Responses to Comments

on the Additional Investigation Results

National Aeronautics and Space Administration, Jet Propulsion Laboratory, Pasadena, California

December 2008

Figure R1. Groundwater pumping records from production wells in the Monk Hill Subarea since 1960 support NASA's assertion that these wells contained the perchlorate plume originating from JPL.

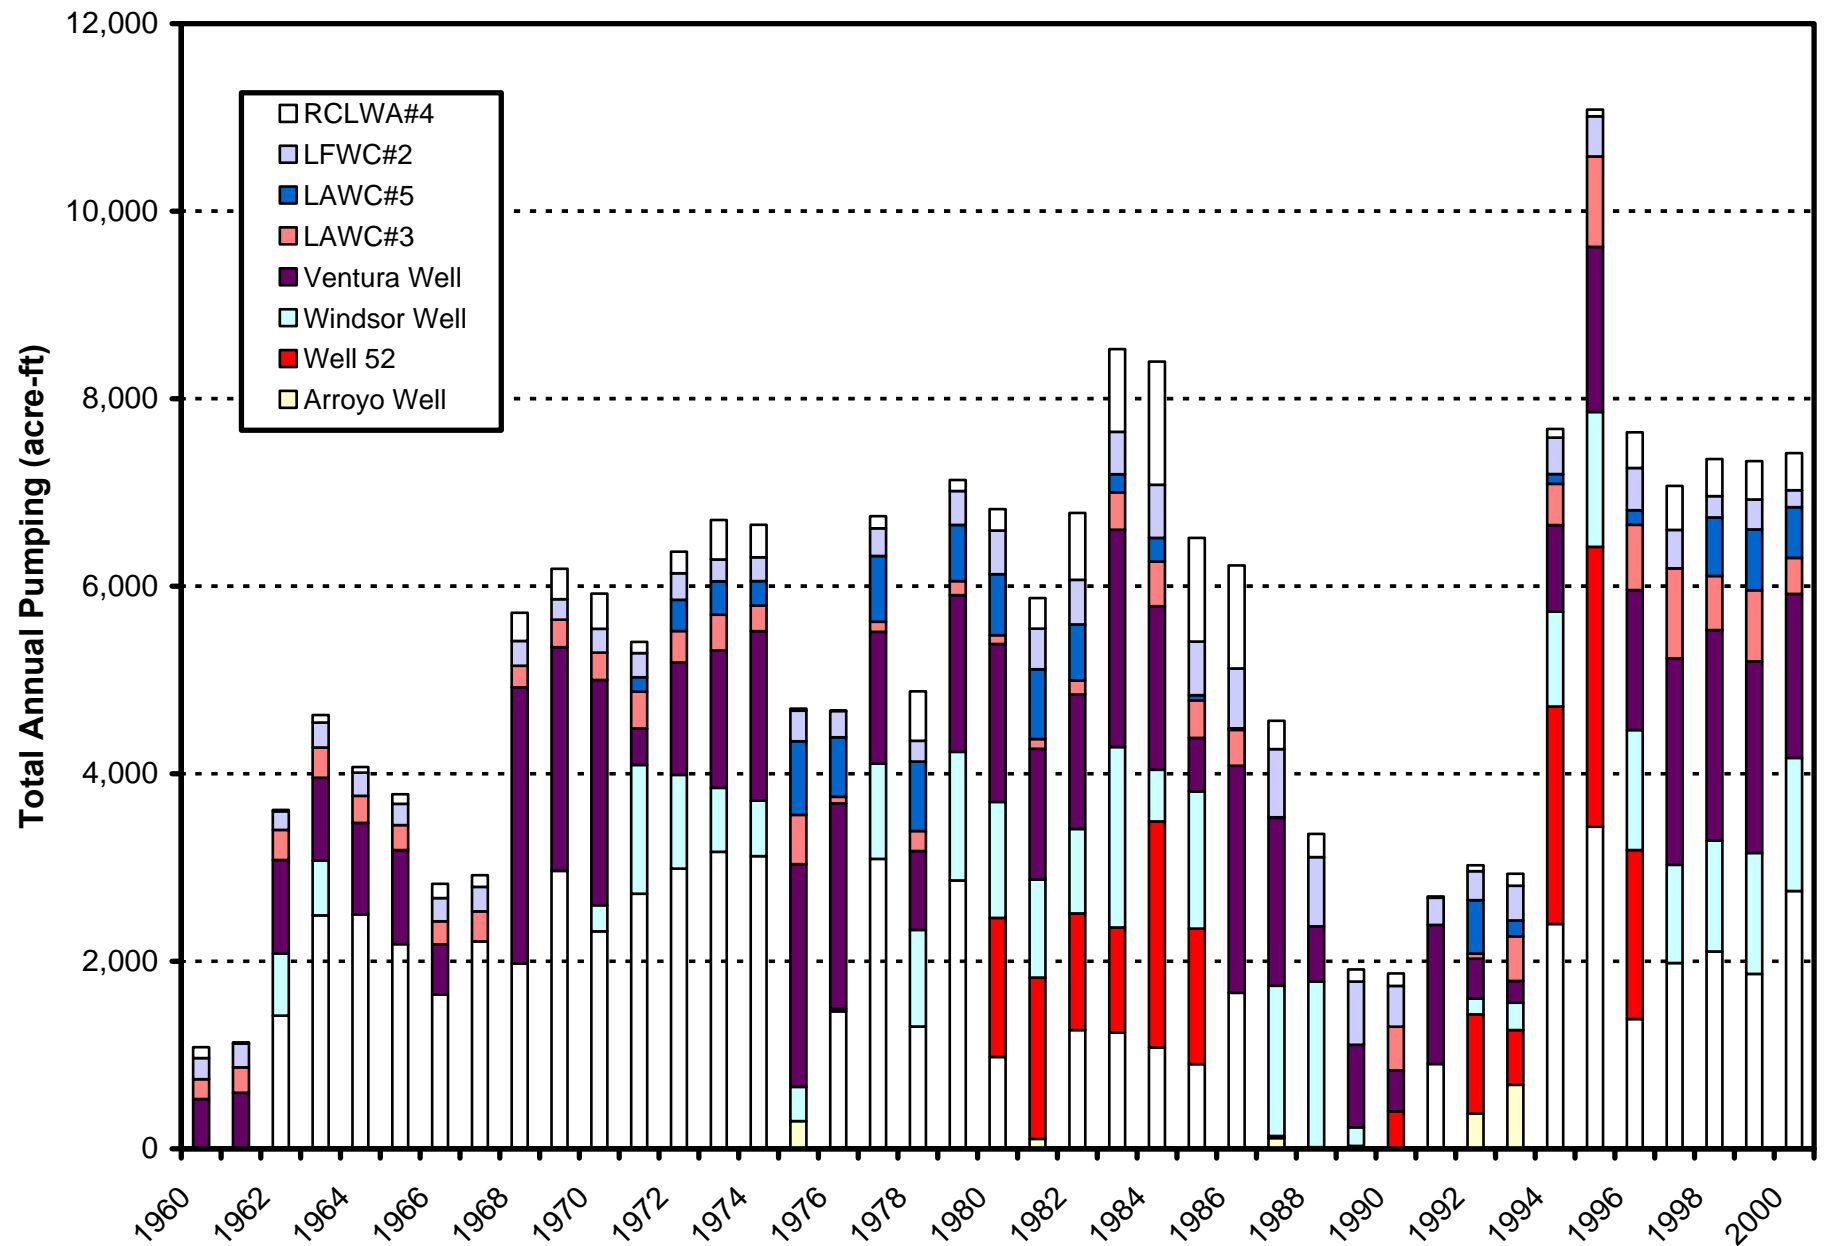
Several comments were received regarding the potential applicability of the two groundwater models to chemical fate and transport, considering that the models were developed for water management (RBMB Model) and plume containment (JPL Model), and considering the potential existence of preferential pathways. The reason why the JPL Model (a model developed to evaluate plume containment) is appropriate for evaluating groundwater flow paths near JPL is that drinking water production wells operating in the Monk Hill Subarea since the early 1900s (that are included in the model) have provided containment of groundwater beneath JPL. The JPL Model is more appropriate than the RBMB Model for evaluating plume containment in the Monk Hill Subarea because it was designed specifically for that purpose, having finer model resolution in the Monk Hill Subarea and near the production wells. The RBMB Model was not developed to evaluate plume containment, but to understand general groundwater transport within the Basin and evaluate various conjunctive use scenarios. Even so, the groundwater flow paths in the Monk Hill Subarea generated by the RBMB Model appear to be consistent with the JPL Model.

As part of the Additional Investigation, the average extraction rates between 1960 and 2000 were used to evaluate capture zones using the JPL Model. This timeframe is believed to be most appropriate given our understanding of when the chemicals were historically released and projected travel times. Perchlorate used during testing at JPL in the mid-1940s and 1950s would have traveled from seepage pits through almost 200 feet of vadose zone and in groundwater approximately 2,500 feet to the closest production well, the Arroyo Well. Conservative estimates indicate vadose zone travel times of at least 7.5 years and travel times in groundwater of approximately 11 years.² As a result, considering average extraction rates between 1960 and 2000 provides an appropriate evaluation timeframe. Historical pumping records indicate that there are no significant periods of time since 1960 that City of Pasadena and Lincoln Avenue Water Company (LAWC) wells in the Monk Hill Subarea were not operational other than the 1985 to 1990 time period of minimal operation discussed in the Additional Investigation Technical Memorandum (see Figure R1). Therefore, based on the JPL Model, these wells provided effective containment of groundwater originating from JPL over the past 50 years.

Figure R2. Groundwater pumping and the bedrock surface are the primary factors influencing groundwater flow paths in the Monk Hill Subarea. The bedrock valley shown on cross-section B-B' channels flow from the Monk Hill Subarea toward the Sunset Reservoir wells.

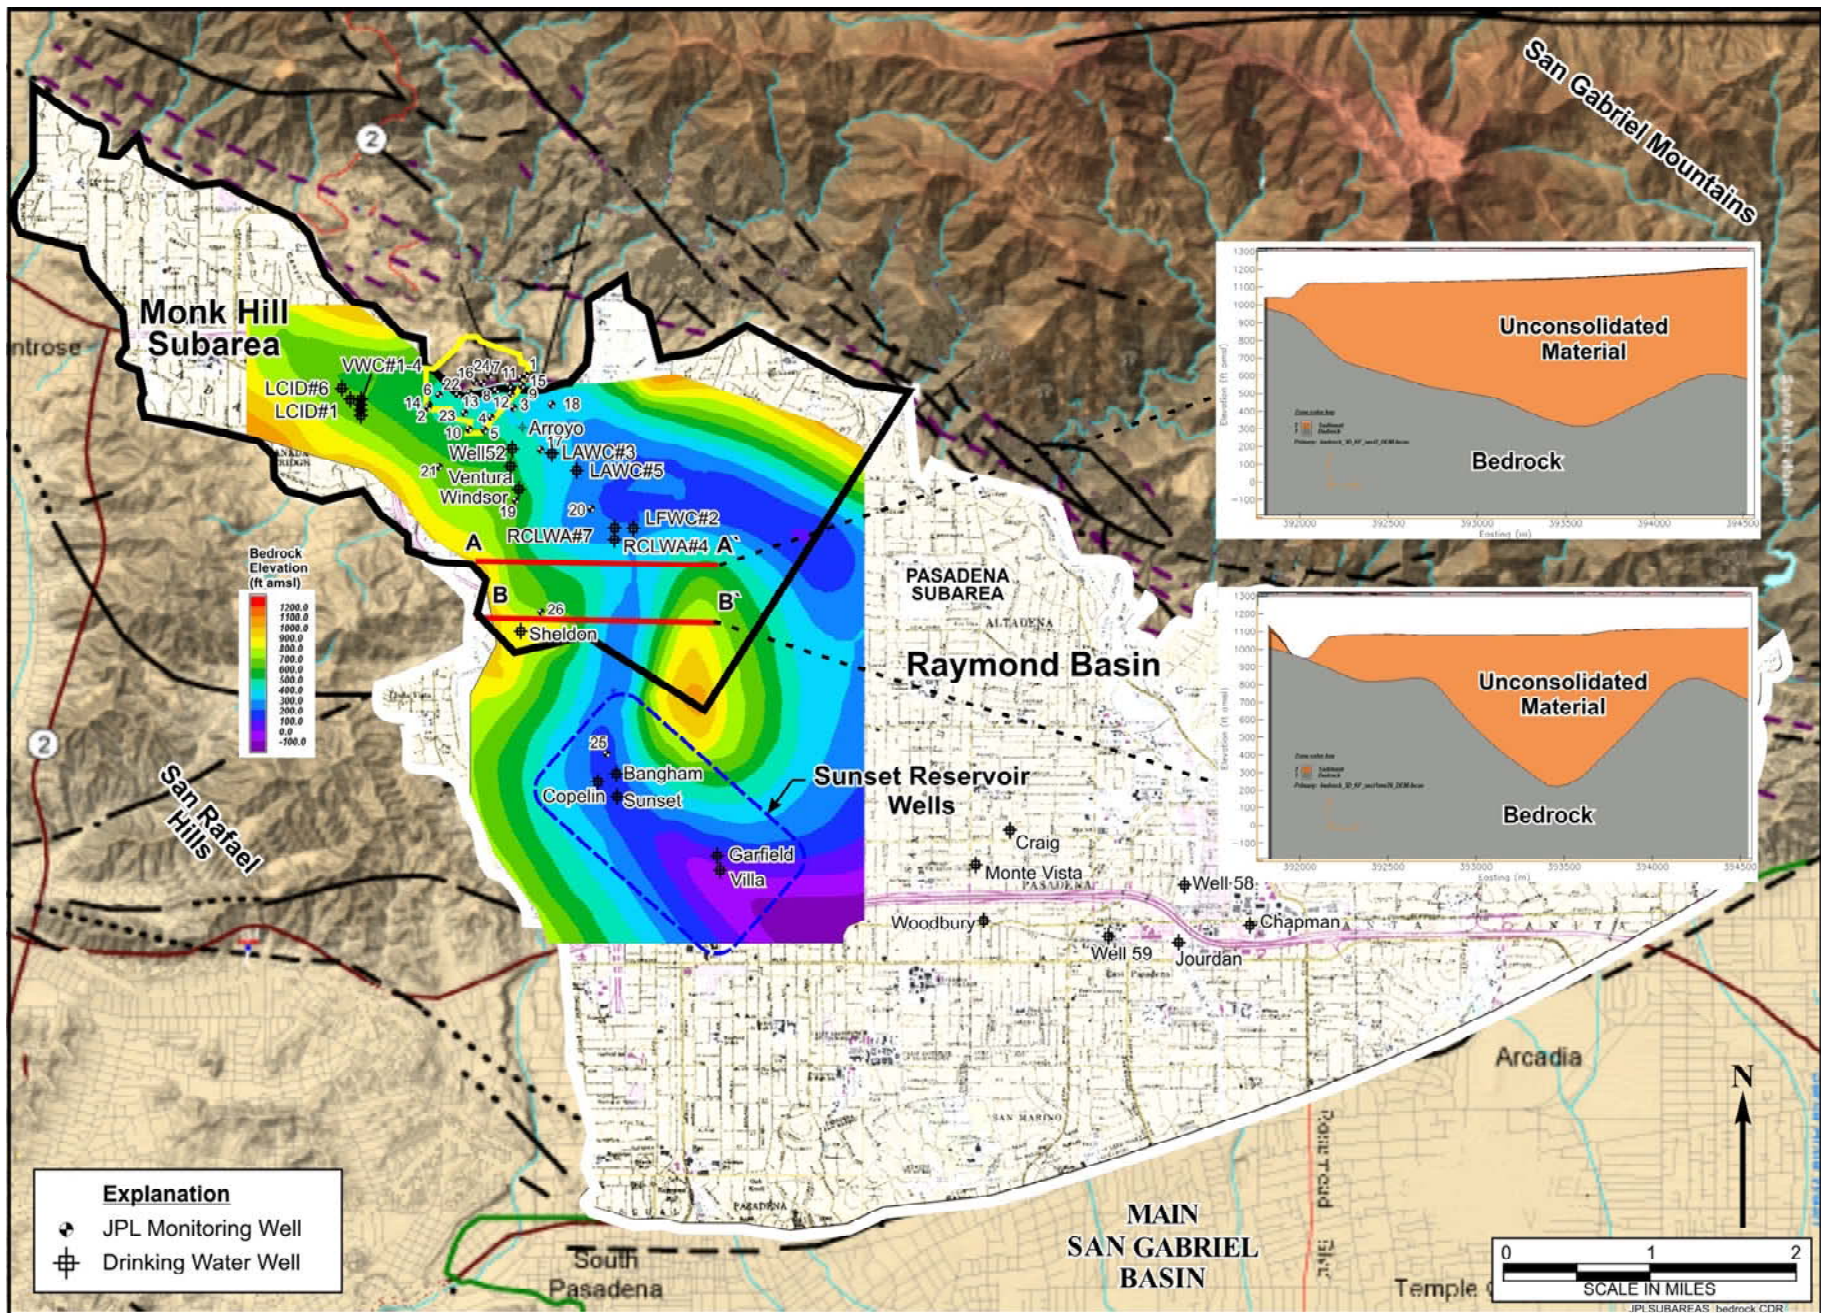
DTSC Comment No. 17 – While Figures 7 and 8 may suggest recharge along the western corridor, the particle tracking maps certainly do not, and in fact, the conspicuous absence of a groundwater mound associated with the Golf Course is a strong argument for anisotropic conditions beneath the Arroyo.

Data collected during the RI, the JPL modeling effort, and the RBMB modeling effort indicate that groundwater flow is primarily controlled by the bedrock surface (see general response Figure R2) and pumping, not the current location of the Arroyo Seco stream bed, which is over 100 feet above the groundwater table near JPL. No monitoring wells are located in the Golf Course to evaluate the presence or absence of a groundwater mound.

Figure R4. Perchlorate and carbon tetrachloride results in LAW3 (top) and LAW5 (bottom), which are located near the leading edge of the JPL plume, support the connection between these two chemicals and the applicability of carbon tetrachloride as a tracer for chemicals originating from JPL.

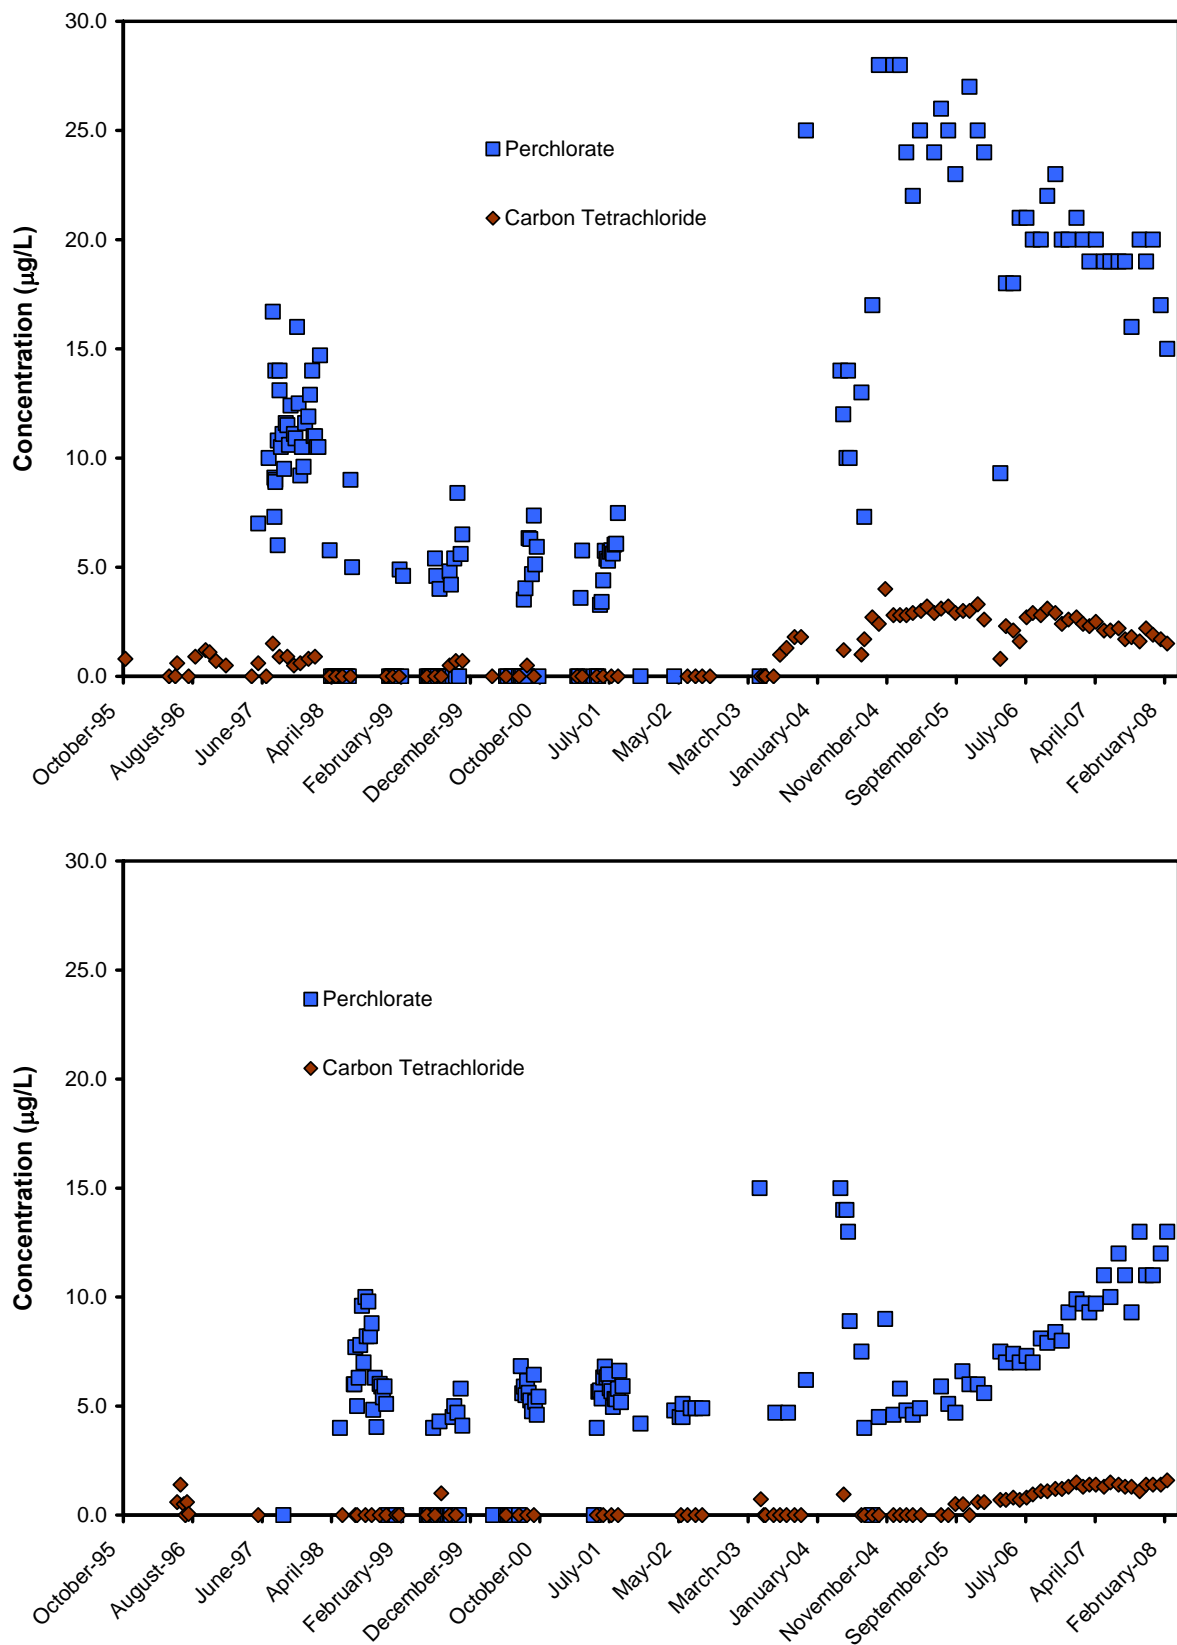
Some comments questioned the applicability of carbon tetrachloride as a tracer for chemicals originating from JPL, considering relative concentrations, potential biological degradation, and differences in chemical properties impacting sorption to aquifer materials. NASA understands that in the absence of containment, perchlorate would likely travel more rapidly than carbon tetrachloride due to differences in their chemical properties (i.e., carbon tetrachloride will attach to organic matter in the aquifer matrix more readily than perchlorate). However, groundwater modeling and historical pumping records indicate that containment has occurred; therefore, it is possible to use carbon tetrachloride as an appropriate tracer. In addition, understanding the extent of carbon tetrachloride strengthens our understanding JPL's perchlorate plume because the carbon tetrachloride data support the groundwater modeling results and our understanding capture zones.

A strong correlation between perchlorate and carbon tetrachloride is observed at the JPL source area and as far downgradient as the LAWC wells, located approximately one mile from JPL. Figure R4 shows the carbon tetrachloride and perchlorate results in the two LAWC wells (LAWC#3 and LAWC#5) since the mid-1990s. These two wells are currently part of NASA's OU-3 response action⁹ to contain the leading edge of the plume. At the LAWC wells, carbon tetrachloride concentrations are approximately one order of magnitude lower than perchlorate concentrations. However, the detection limit for carbon tetrachloride is also about one order of magnitude lower than the detection limit for perchlorate. Therefore, the use of carbon tetrachloride as a tracer is not limited by the relative concentrations between it and perchlorate.

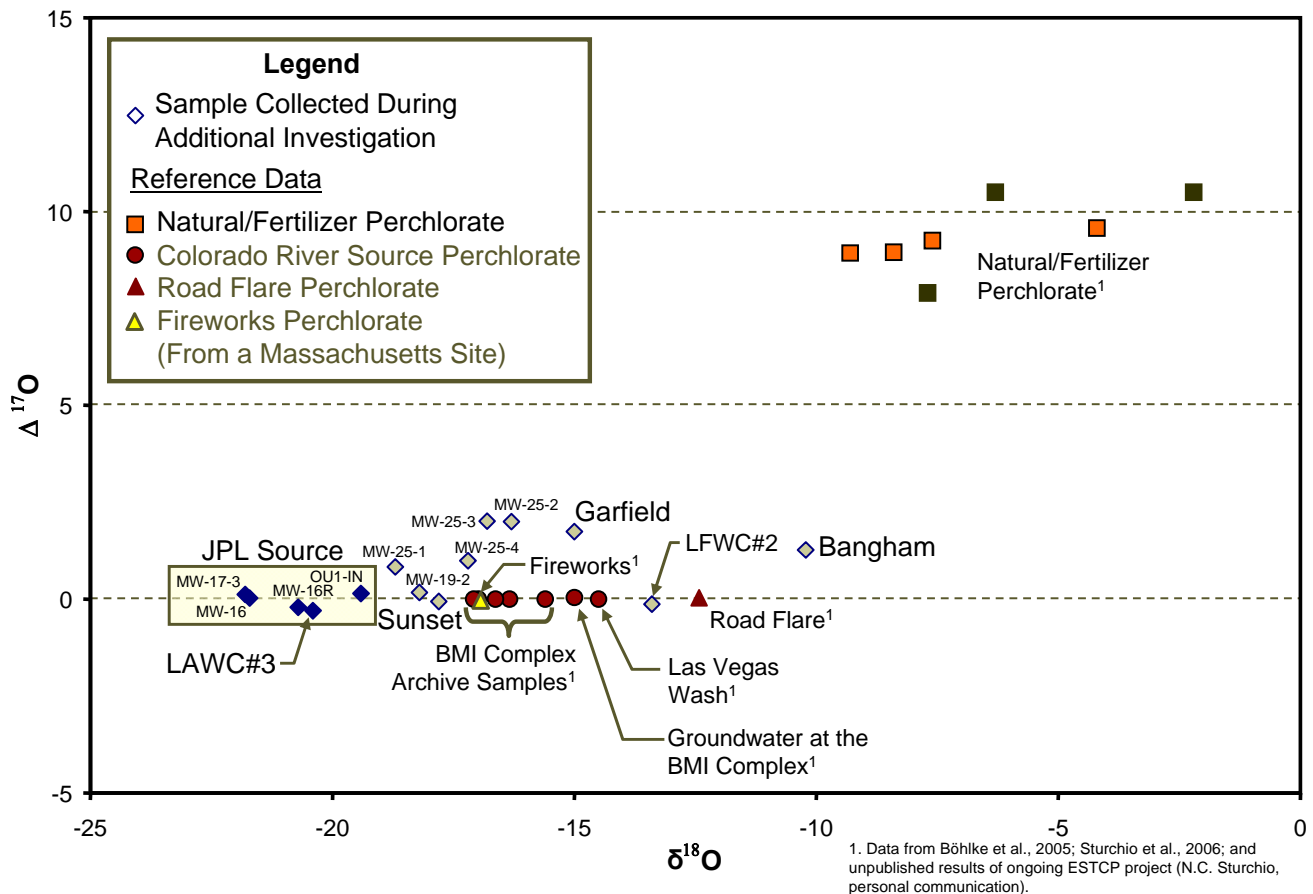
The last general grouping of comments was associated with the perchlorate isotope data. EPA and DTSC concurred with NASA's interpretation that the perchlorate isotope data indicate multiple sources of perchlorate in the Basin, but questioned whether the isotope data eliminated JPL as a source in the Sunset Reservoir wells.

During the Additional Investigation, samples from three of the five Sunset Reservoir wells, including Bangham Well, Garfield Well, and Sunset Well, were analyzed for perchlorate isotope composition. Bangham Well and Garfield Well isotopic data cannot be explained by mixing of JPL perchlorate and other sources (see Figure R5), as their ¹⁸O composition is much heavier than JPL and both appear to have a significant contribution from natural/fertilizer perchlorate.

Upon initial evaluation, it might appear that the perchlorate in groundwater collected from the Sunset Well is a mixture of JPL perchlorate and other sources. NASA's conclusion that Sunset Well does not contain JPL perchlorate is supported by isotope data from MW-19 (Screen 2), which is isotopically indistinguishable from that from the Sunset Well. Since MW-19 is a JPL monitoring well, much is known about this well, including that the source of perchlorate in MW-19 (Screen 2) did not originate from JPL. We know that carbon tetrachloride has never been detected in MW-19 (Screen 2) even though it is less than a mile from JPL. This is because MW-19 is cross-gradient from JPL (i.e., not within the flow path of groundwater originating from JPL). In addition, tritium data indicate recently recharged water at this well location, which is consistent with injection of imported water upgradient of MW-19 in the Valley Water Company wells. Also, groundwater modeling indicates that groundwater cross-gradient and to the west of JPL flows past MW-19 and on toward the Sunset Reservoir wells. Therefore, MW-19 (Screen 2) and the Sunset Well may contain perchlorate from the same source, but not from JPL.
